Introduction

The Roadway Criteria Section has tracked 83 changes being made between the 2025 & 2026 **FDOT Design Manual (FDM)** through the standard update process as described in the **FDM Update Process**. Seven chapters were updated with non-substantive changes during 2025 and posted as *errata*, and one chapter (**227 Freight Facilities**) is expected to be released prior to the publication of the 2026 **FDM** through a bulletin from the Office of Freight and Rail.

Item 1: Design Approval Process

216.4.6.1 Retaining Wall Embankment

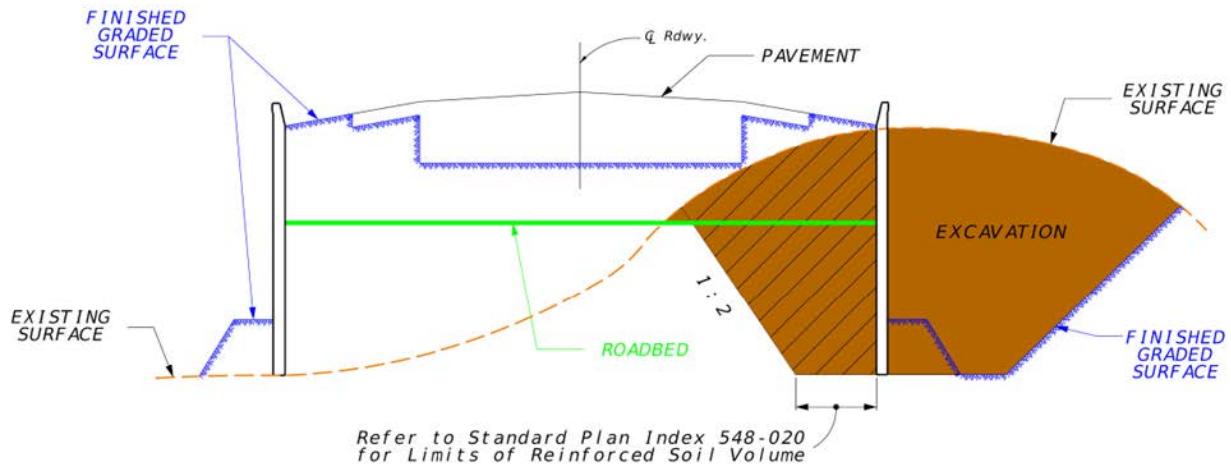
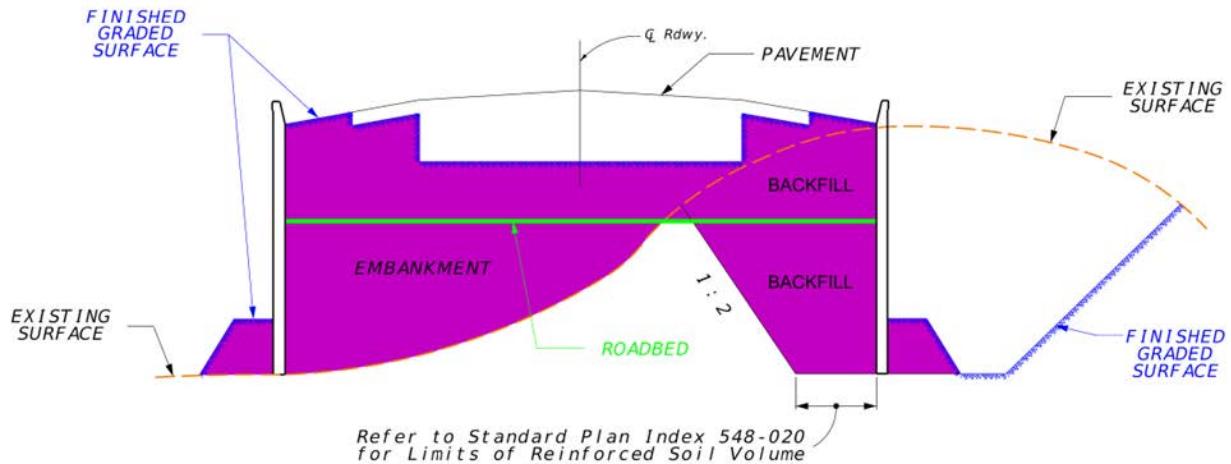
Summary: Added a new section in FDM 216 for Retaining Wall Embankment to give guidance and direction to designers on calculating embankment costs and added a sentence to FDM 262 requiring coordination between the roadway EOR and the structures EOR to identify earthwork quantities.

Excavation for retaining wall construction is included in the cost of the retaining wall, but the cost of backfill or embankment for retaining walls is included in the cost of embankment. Calculate the embankment volume as illustrated in *Figure 216.4.9*. The limits of soil volumes for retaining walls depend on the requirements in *Standard Plans Index 548-020*, retaining wall strap length design, and the soil slope (typically 1:2). Coordinate with the structures design engineer on the retaining wall design and reinforced soil volumes. See *Standard Specifications Section 548* for more information on Retaining Wall Systems.

Excavation Included in Cost of Retaining Wall

Backfill and Embankment to be Included in the Total Embankment Volume
